**EAST GOSHEN TOWNSHIP
PLANNING COMMISSION
Meeting Agenda
Wednesday, July 1, 2020
VIA Telephone / Video Conference
7:00 PM**

Date: 6/25/2020
To: Planning Commission
From: Mark Gordon, Township Zoning Officer *mlg*
Re: Synthes USA / JABIL / Land Development Application

**RE: Jabil Finishing Plant Expansion, 1303 Goshen Parkway
Preliminary/Final Land Development Plan – 2nd Submission**

RE: 1303 Goshen Parkway – Preliminary / Final Land Development
Jabil Finishing Plant Expansion
1303 Goshen Parkway, West Chester, PA 19380
Mainstay Project Number: 19360
Pennoni / EGT Reference: EGOST00131

Drawing No.
C5.01

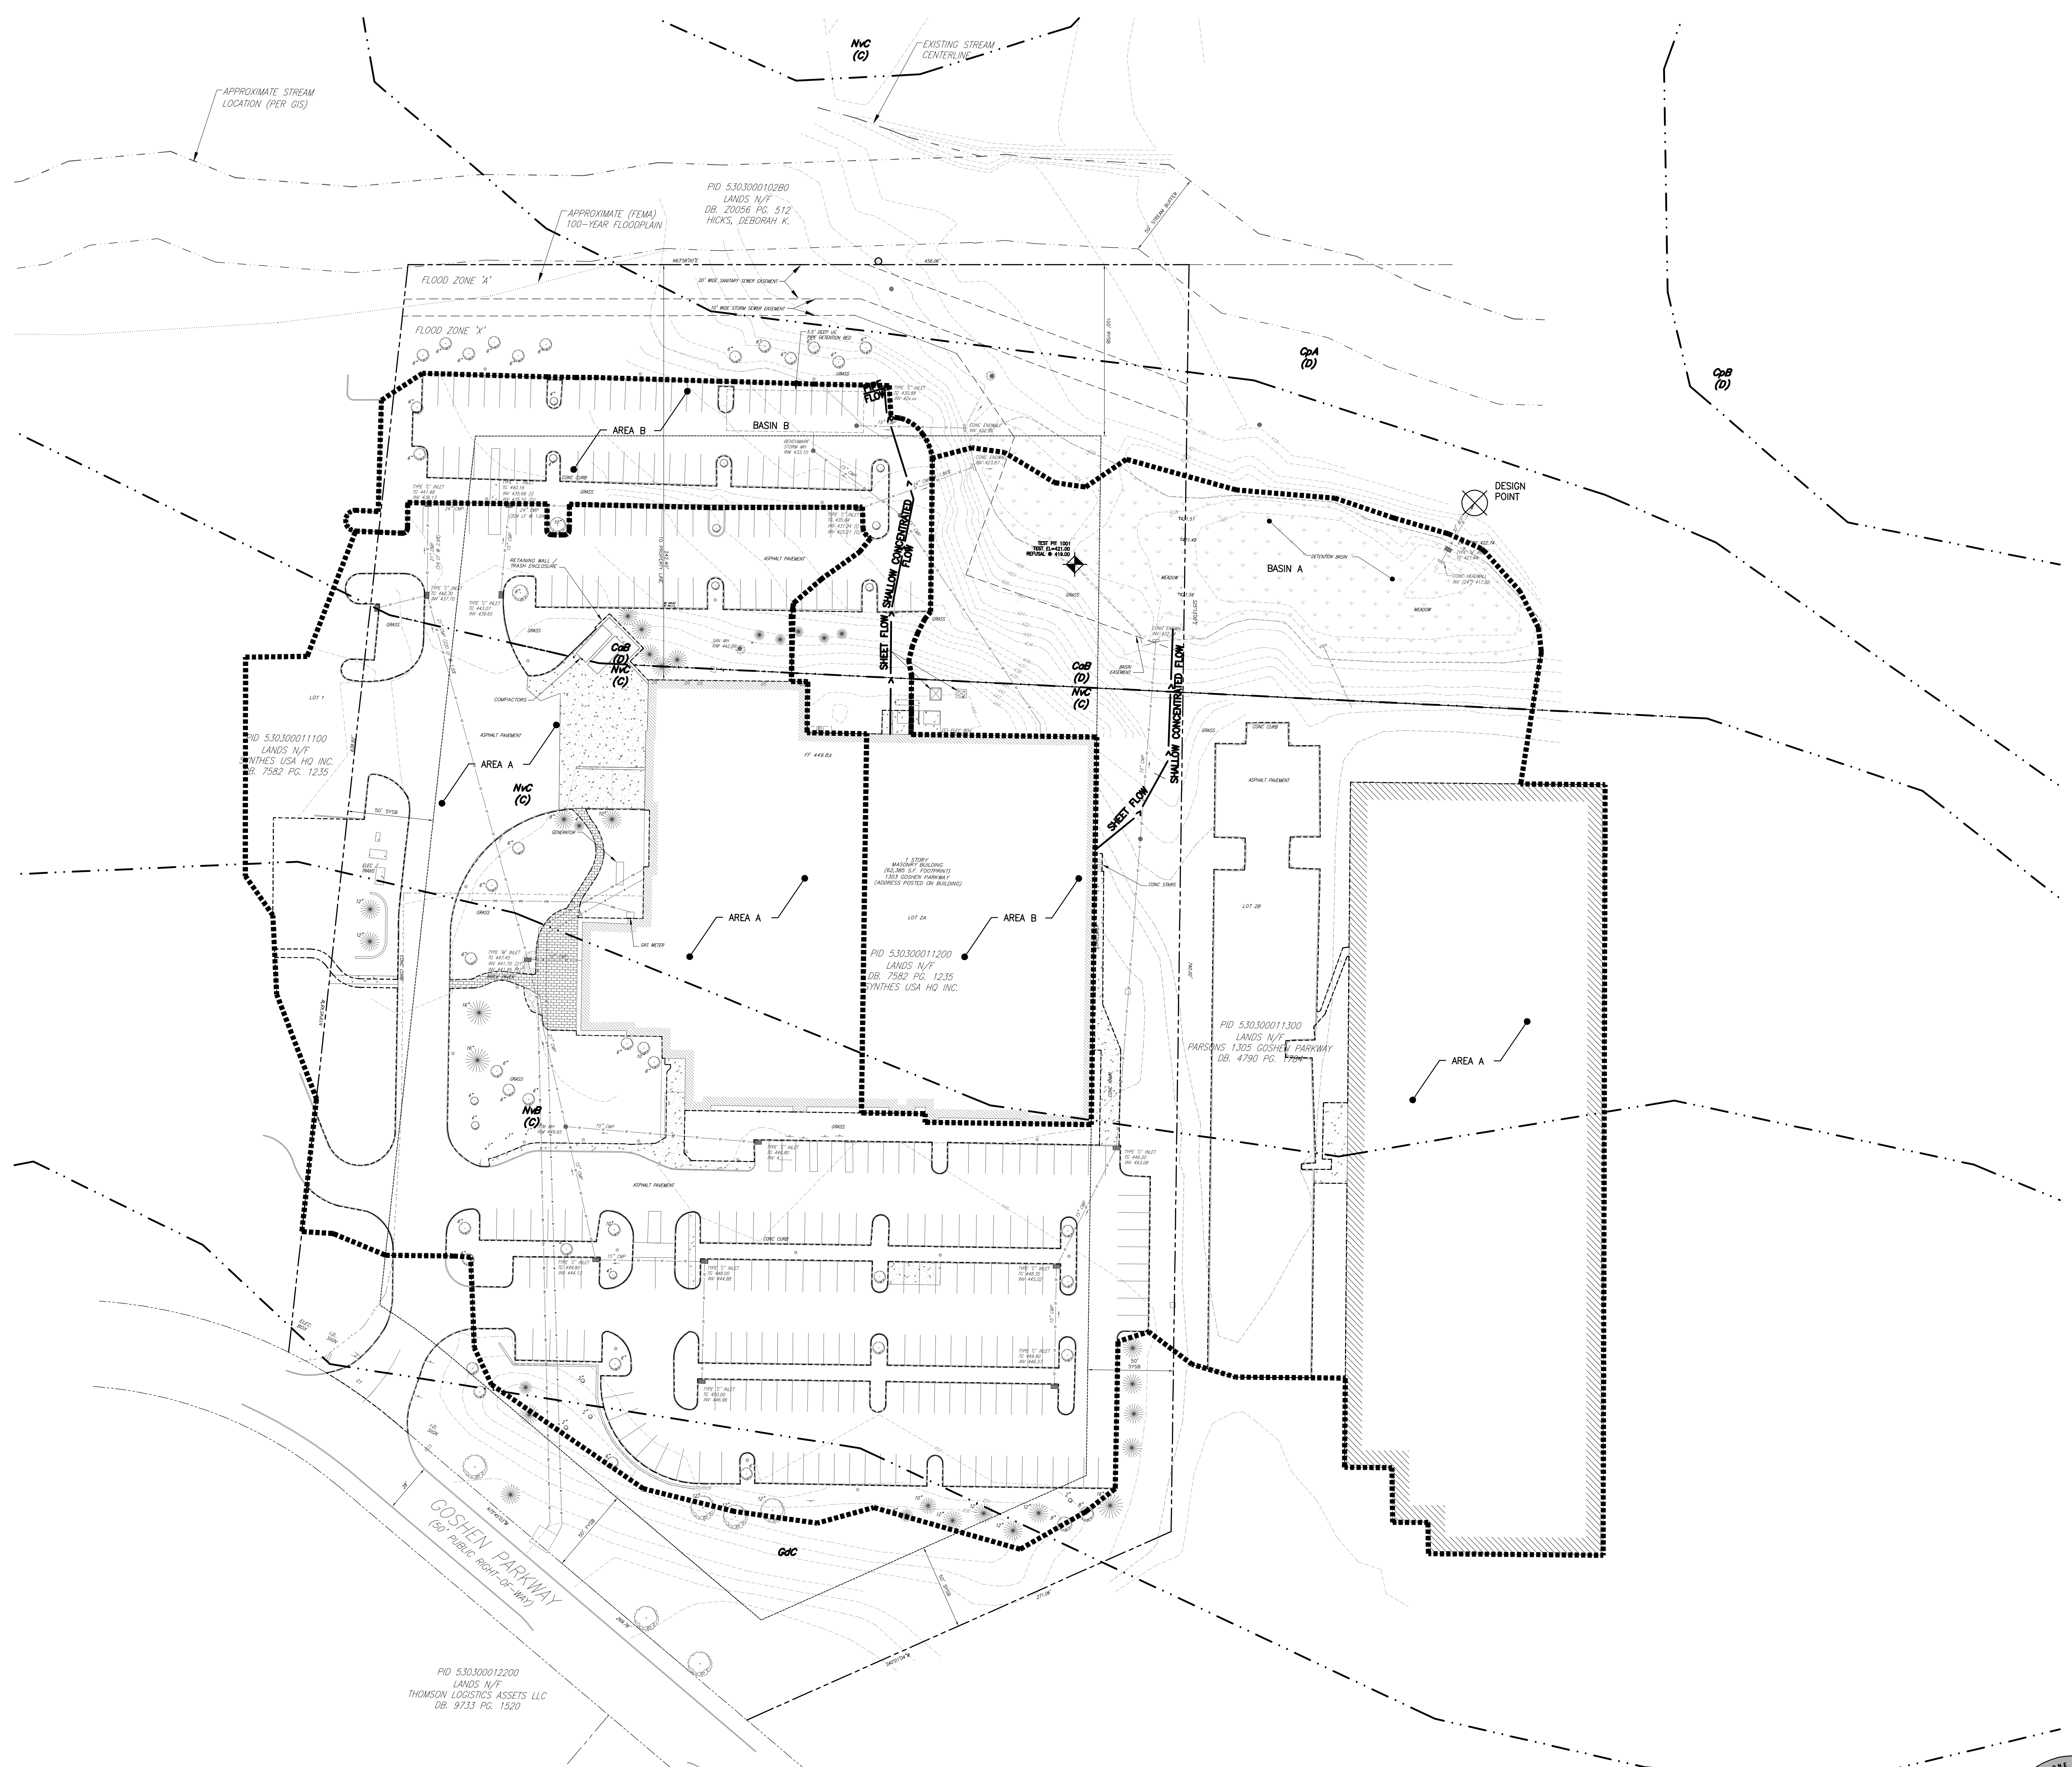
4. A detail for the proposed lighting shall be provided to confirm the light is completely shielded and/or covered by an appropriate translucent cover. (§240-27.C(7)(b))

Outstanding. It appears the applicant has provided a detail for the lighting adjacent to the walkway however no detail has been provided for the parking lot light.

A detail has been provided on the Lighting and Landscaping Plan (Sheet C5.01).

Drawing No.: **C6.01**

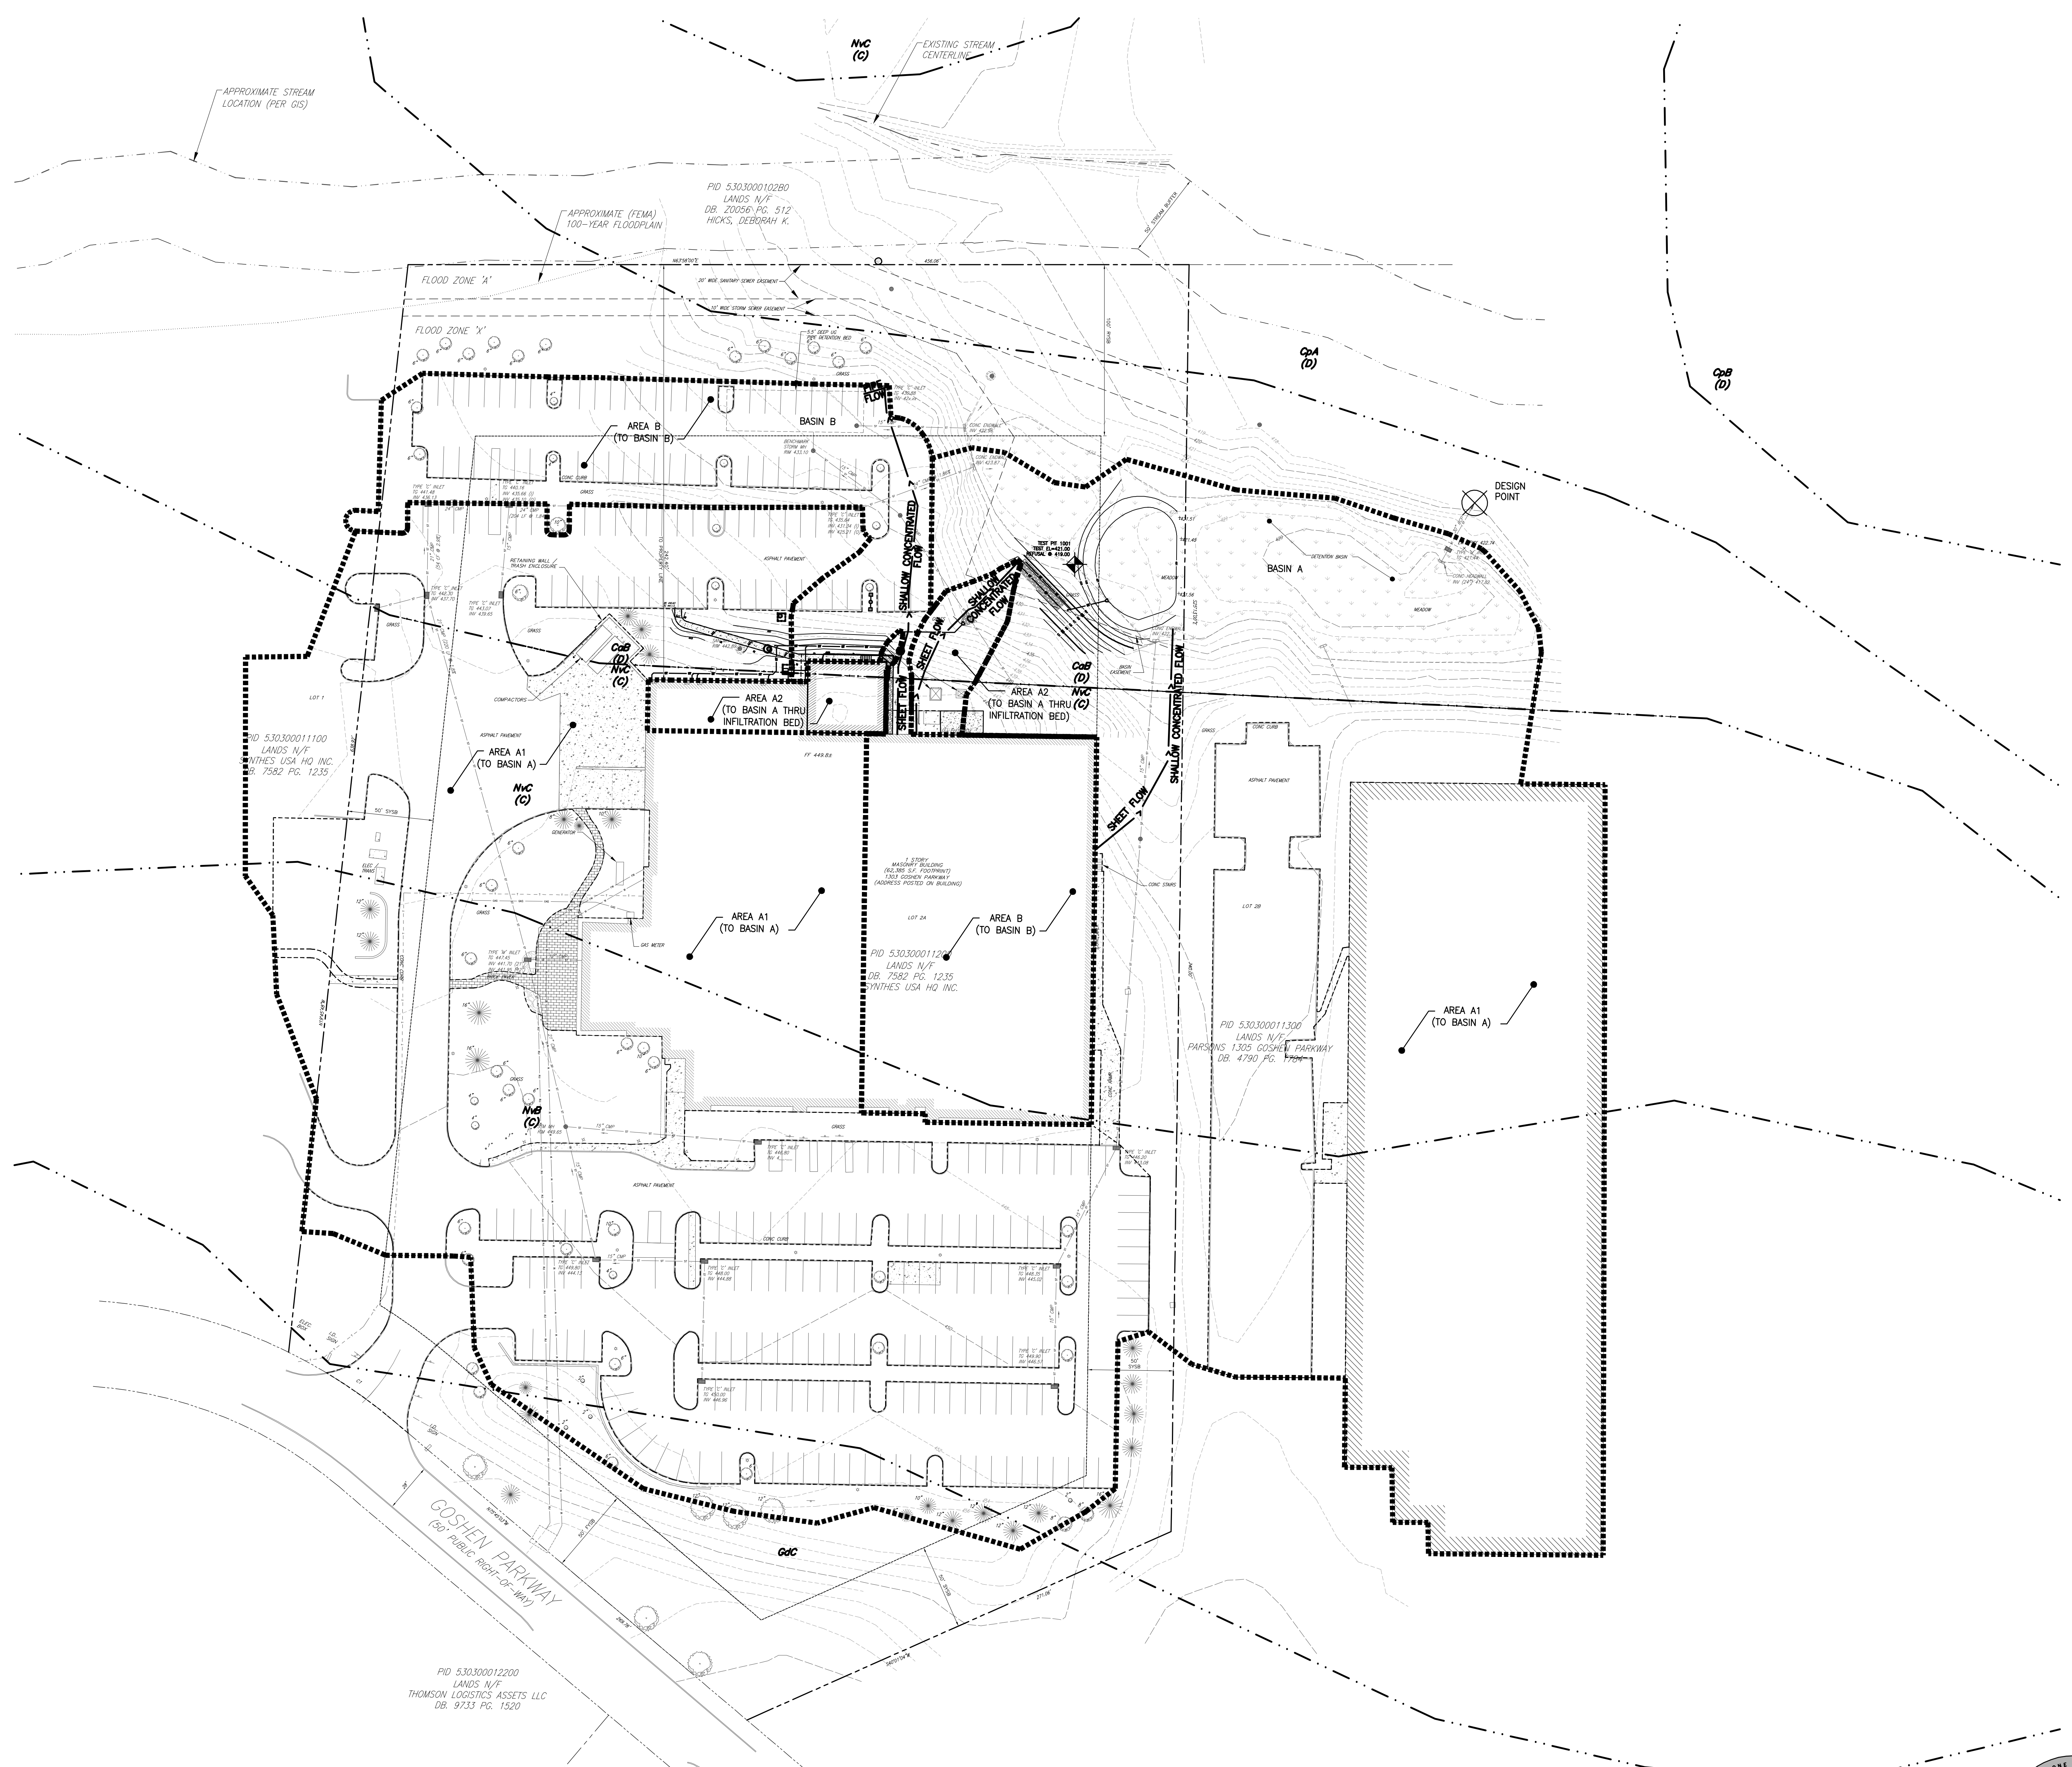
10. Please provide the location of the test pit used for the design of the proposed infiltration facility on the plan. (§195-20.I)

25. The applicant should provide an easement granting the Township ingress and egress to the stormwater BMP's. Note: a blanket easement is acceptable; see below. (§195-27.B(18)(c))

26. Per §195-39, the Township requests that the following be added to the plans regarding stormwater management easement:

Resolved. The applicant has offered a blanket easement on a note on Sheet C6.01.

Resolved. The applicant added the note to Sheet C6.01.

Test pit location has been located on the Post-Development Drainage Plan (Sheet C6.01). Refer to infiltration report in the Stormwater Narrative appendix.

A blanket easement as noted below has been added to the Stormwater Management Plan (Sheet C6.01).

The aforementioned note has been added to the boxed note located in the upper left corner of the Stormwater Management Plan (Sheet C6.01.)
